Access Compliance Report

Public Rights-of-Way

(Pedestrian Signals)

Intersection ID: N/A	Main Street:	Cross Street: N/A	Location: N/A
ADA ID: C82AB7128675	Signal Type: Two Push Buttons-APS	Overall Compliance: No	Severity Score: BTN 1:N/A BTN 2: N/A No BTN: N/A
Codes/Mitigation Info/Possible Solution		Field Measurements/Component Compliance

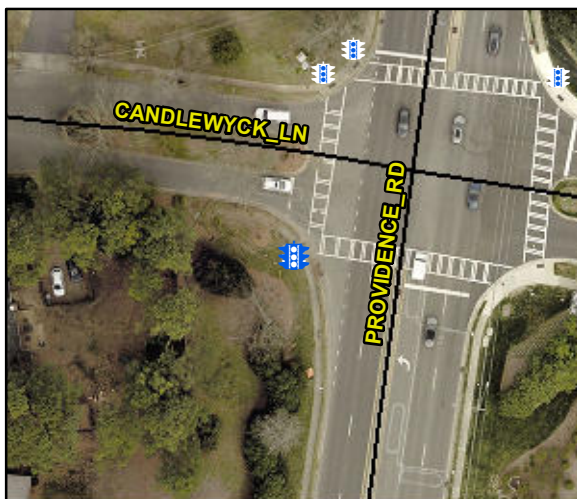
Surveyor Notes: B1 OUT OF SERVICE

PROW/ADA: TMUTCD 4e.08, R404.2, R404.3, R406.2, DMS-11132, MUTCD 4e.08, R104.2, R209.1,

Possible Solutions: Replace Signal Push Button With APS Button on New Post. Remove & Relocate Sign.
